STAFF RECOMMENDATION

1818 Cedar Lane

January 20, 2021

Application: New Construction—Addition and Outbuilding; Setback Determination

Figure 2 (left) is the existing garage. Figure 3 (right) is the 1957 Sanborn map which shows a different garage in a different location than what is existing.

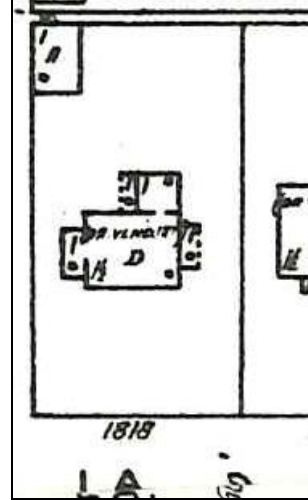
Demolition: The applicant plans to demolish the existing outbuilding on the lot (Figure 2). The date of construction of the outbuilding is not known, but the c. 1957 Sanborn map shows a garage in a different location on the lot so the existing was built after 1957. Staff finds that due to its date of construction and its lack of historic character, that the garage does not contribute to the historic character of the site nor to the Belmont-Hillsboro Neighborhood Conservation Zoning Overlay. Staff therefore finds that its demolition meets the design guidelines for appropriate demolition.

Staff finds that the removal of the garage, existing addition on the right façade, and gable window on the right façade are appropriate demolition that meet Section V.B.2. of the design guidelines.

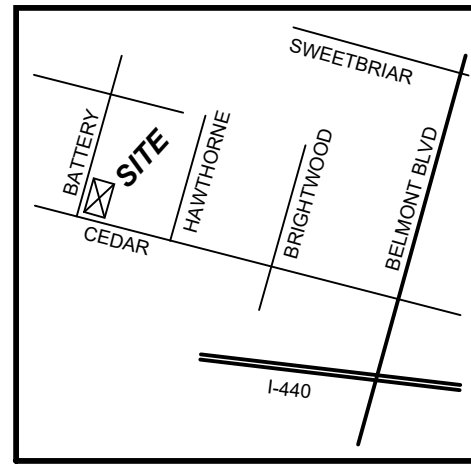
* The design guidelines state that there should be a minimum of twenty feet (20') between the back of the addition and any outbuilding. However, the applicant is proposing a space of just fifteen feet (15'). Staff finds that the propose distance of fifteen feet (15') is appropriate for this site because there is an existing garage that sits just a few feet from the back of the house. Because there is a similar existing condition, staff finds that the distance of fifteen feet (15') meets the design guidelines.

** Base zoning requires a twenty-foot (20') side setback from a side street when the garage doors face the street, but the applicant is proposing a setback of just ten feet (10') from the Battery Place property line. Staff finds that the setback of ten feet (10') is

appropriate for this site because it is not forward of the bay of the historic house. In addition, Battery Place is just one block long, running from Cedar to Wildwood, and no houses face Battery Place. The Commission has approved ten-foot (10') setbacks for garages on similar lots.

Overall, staff finds that the outbuilding's height, scale, roof form, materials, location, and setbacks to meet Section II.B.1.i. of the design guidelines.

BOUNDARY & TOPOGRAPHIC SURVEY
LOT 1
PLAN OF A.B. MONTGOMERY'S LANDS SUBDIVISION
 FOR
PHIL HYDE
 PROPERTY ADDRESS:
 1818 CEDAR LANE
 NASHVILLE, TN. 37212
 18TH COUNCIL DISTRICT
 NASHVILLE, DAVIDSON COUNTY
 TENNESSEE
 DATE: OCT. 06, 2020

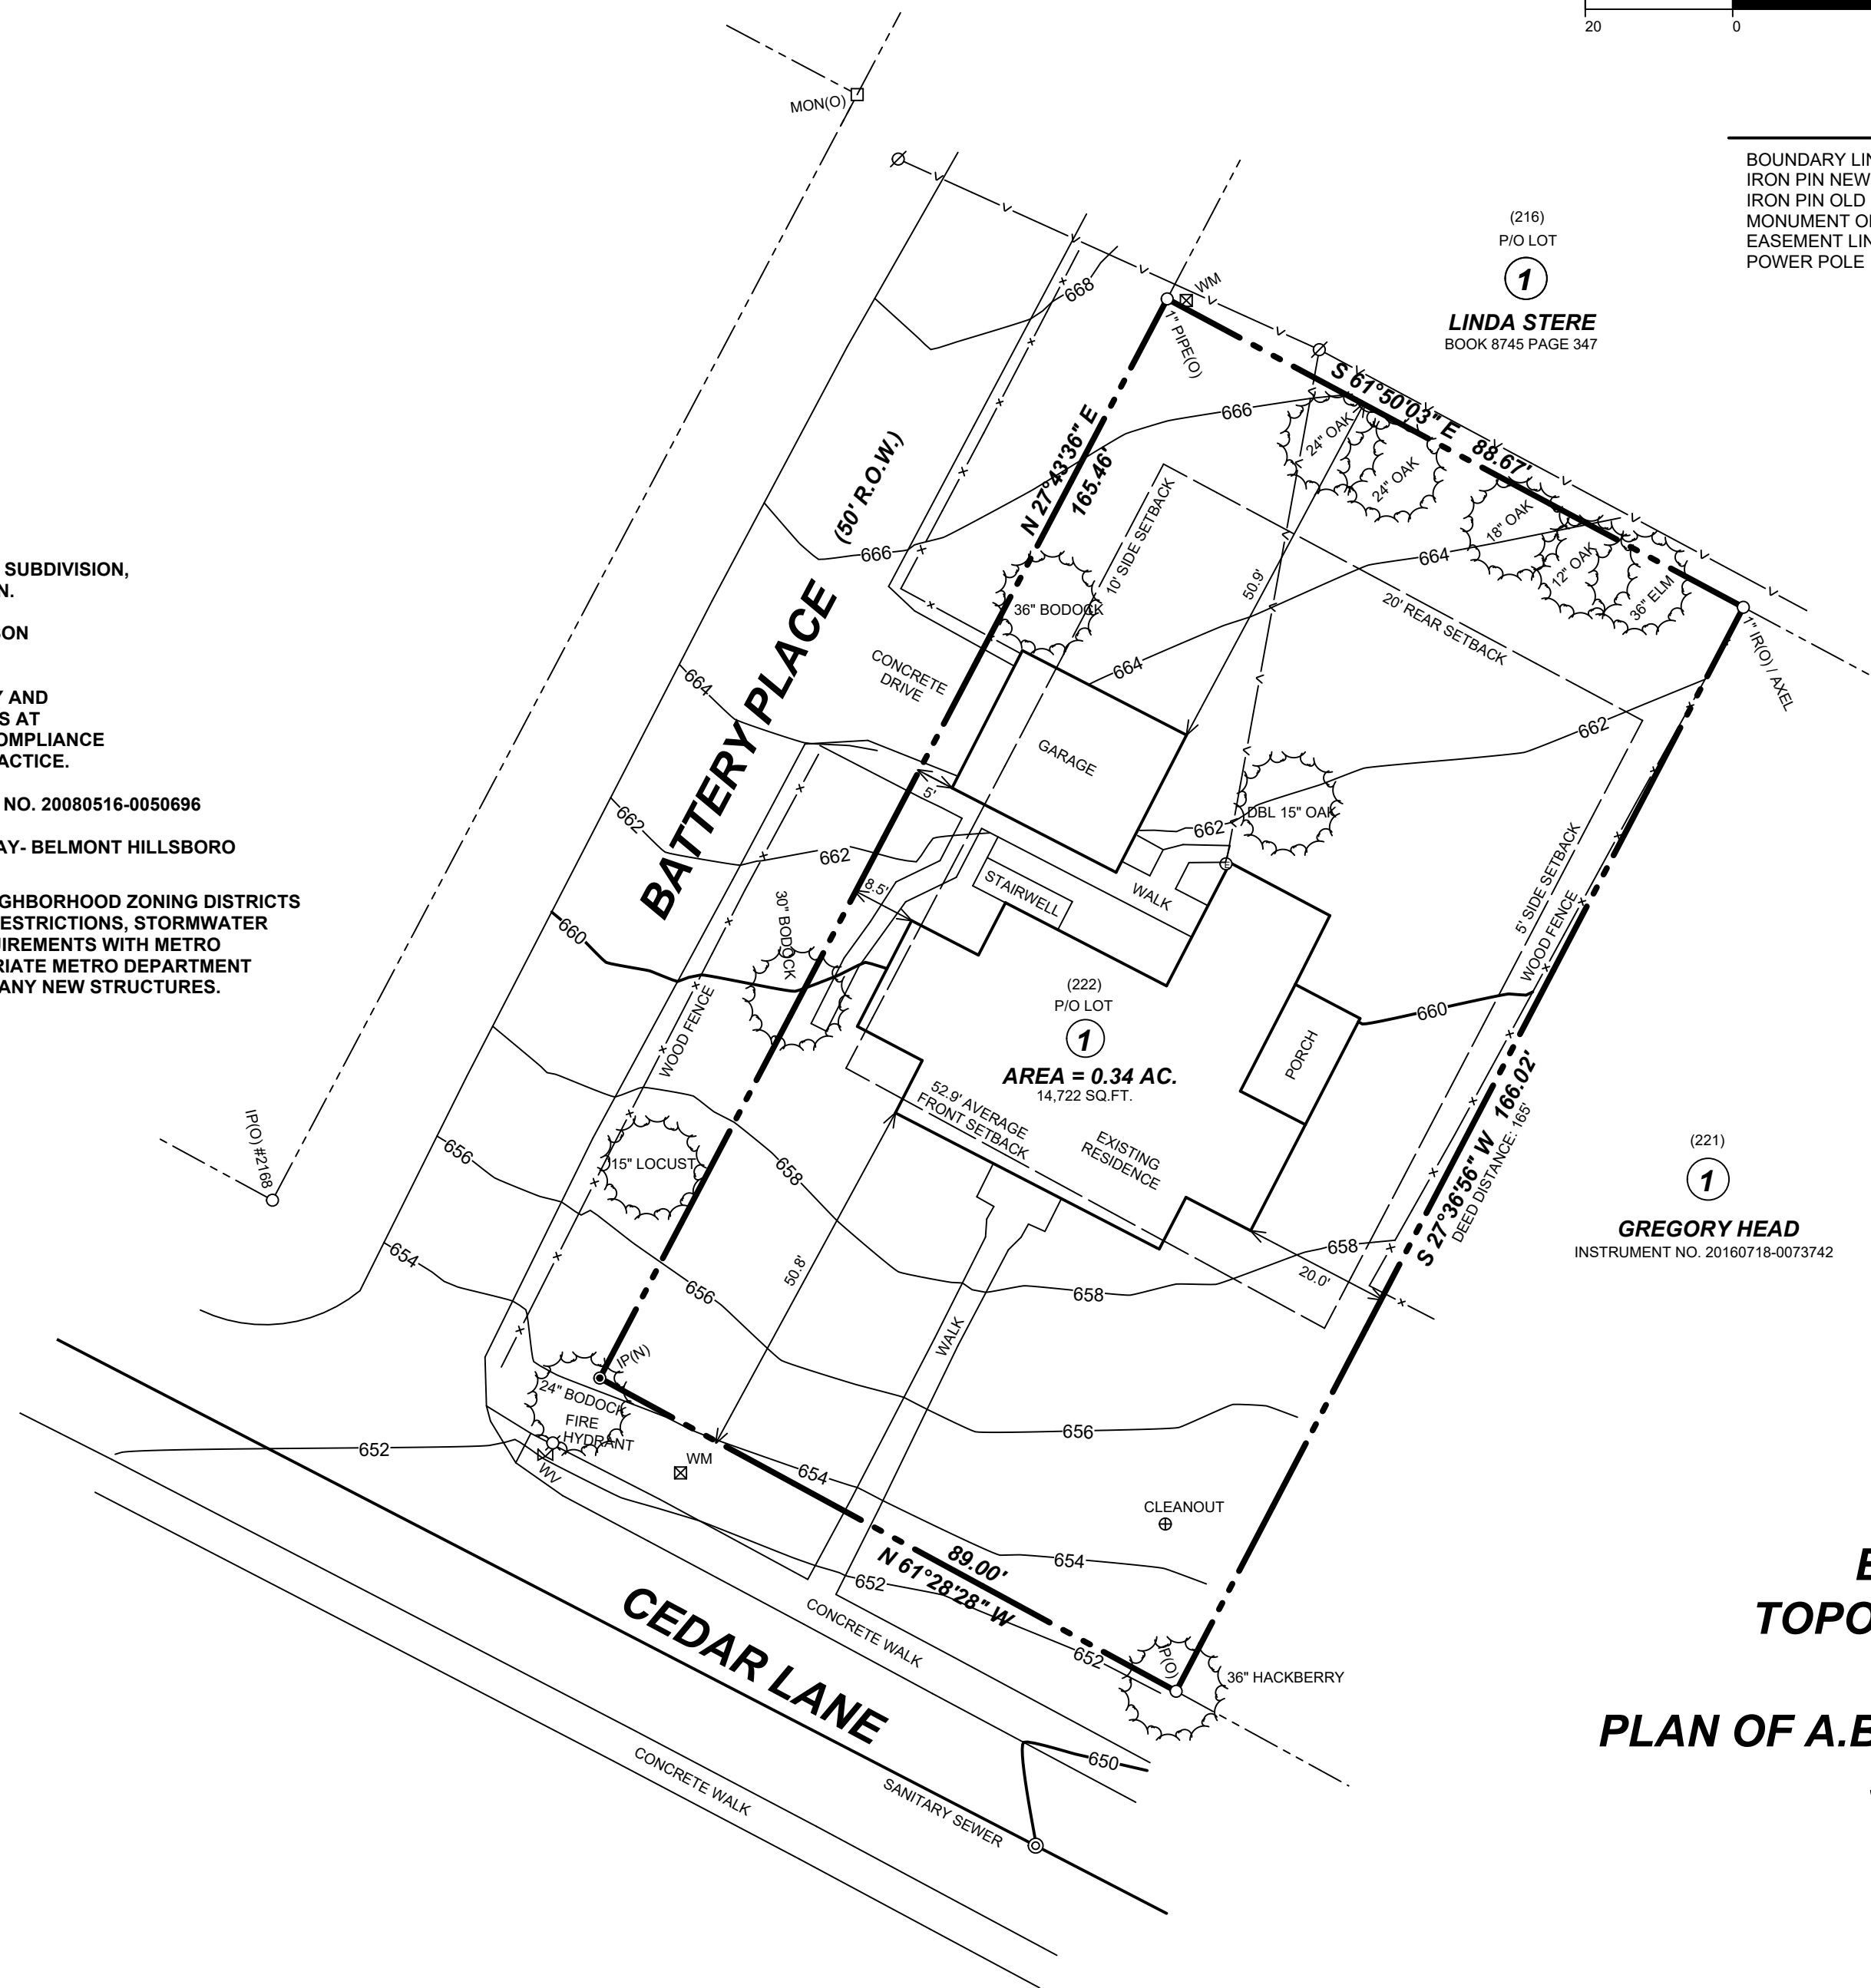
Setback & Rhythm of Spacing: The addition meets all base zoning setbacks. It will be approximately thirteen feet (13’) from the Battery Place side property line, twenty feet (20’) from the right property line, and over forty feet (40’) from the rear property line. The addition will not affect the historic house’s rhythm of spacing of houses along Cedar Lane.

Staff finds that the addition’s setback and rhythm of spacing to meet Section II.B.1.c. and II.B.2. of the design guidelines.

ROOF PLAN

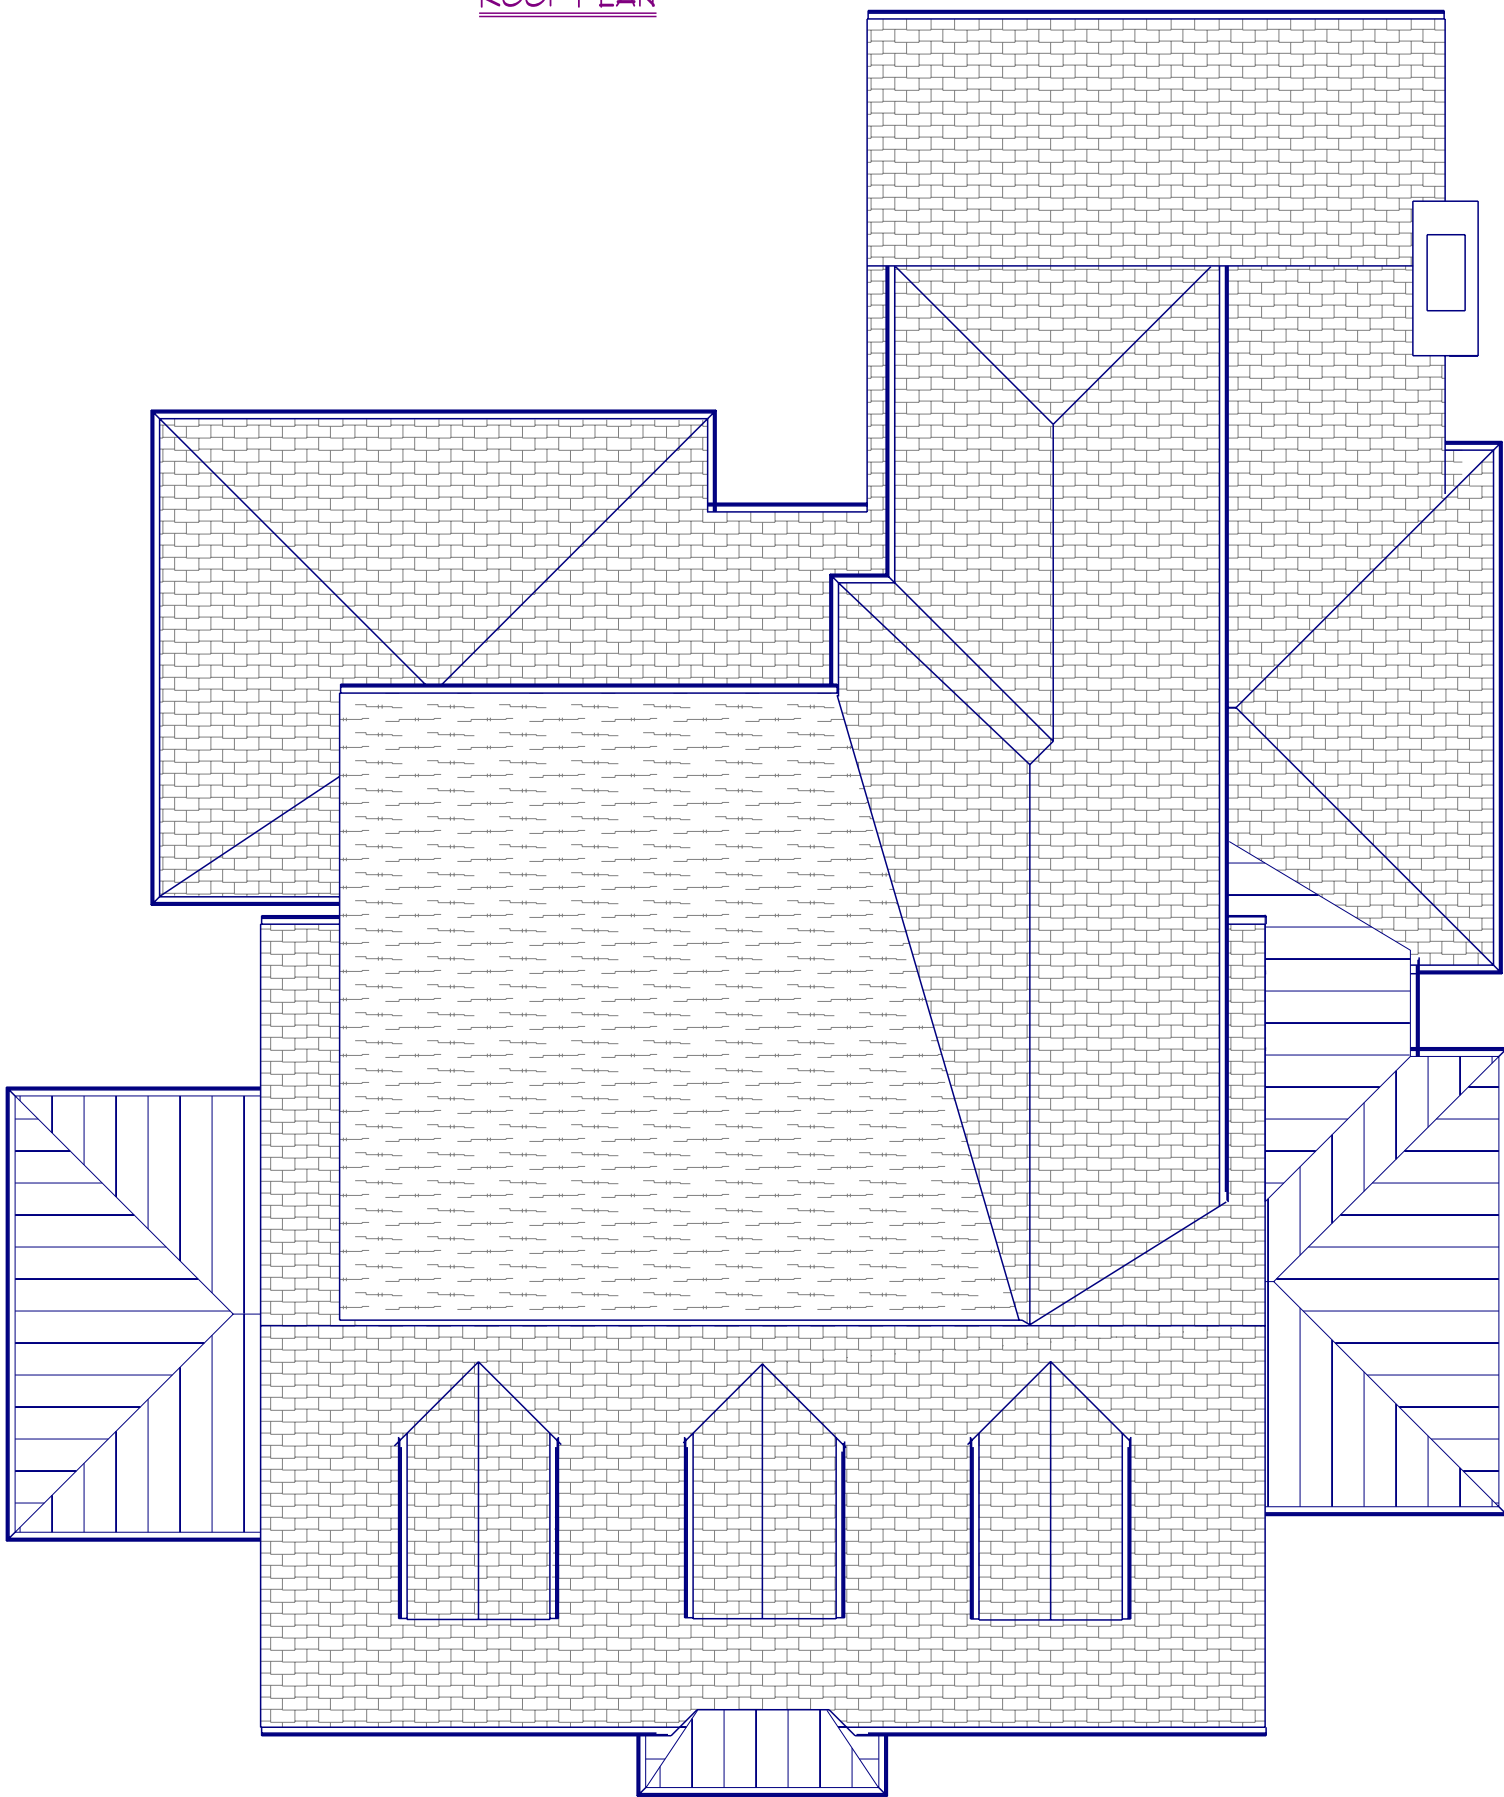
Roof form: The applicant will alter the roof forms on the two existing side wings. They are currently flat, but due to water issues, the applicant proposes to make them 3/12 hipped roofs. Staff finds that this alteration and new roof form to be appropriate because the roof slope is still low and the change is necessary for dealing with water runoff.

The addition has a mix of gable and hipped forms with most slopes being 5/12, 8/12, and 12/12. The rear inset dormer will have a shed roof with a 3/12 slope, which is similar to other shed roof forms approved by the Commission.

Staff finds that the proposed roof forms to be compatible with the historic house’s roof and to meet Sections II.B.1.e. and II.B.2. of the design guidelines.

FRONT ELEV
GARAGE

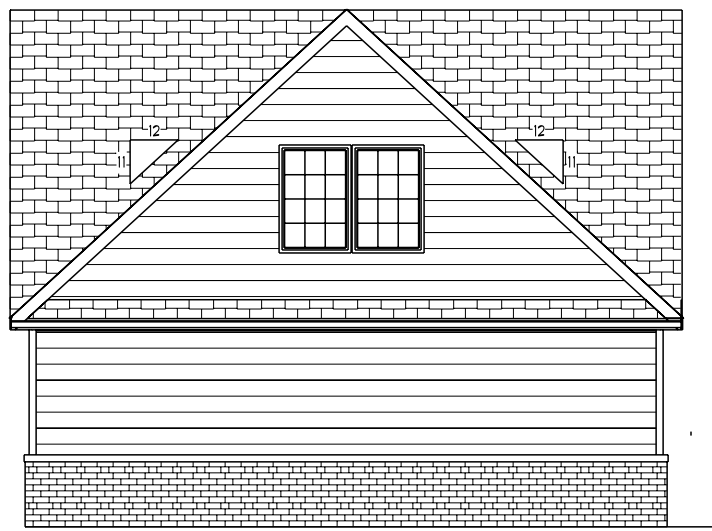
Potential maximums under Ordinance	Existing House	Proposed Outbuilding
Ridge Height	25’ unless existing building is less	22’6”	21’6”

Proposed Element	Proposed Outbuilding	Typical of district?
Primary form	Cross gable	Yes
Primary roof slope	11/12	Yes

Staff finds that the height and scale of the proposed outbuilding to meet the design guidelines.

Staff finds that the proposed roof form meets Section II.B.1.i of the design guidelines for roof shape.
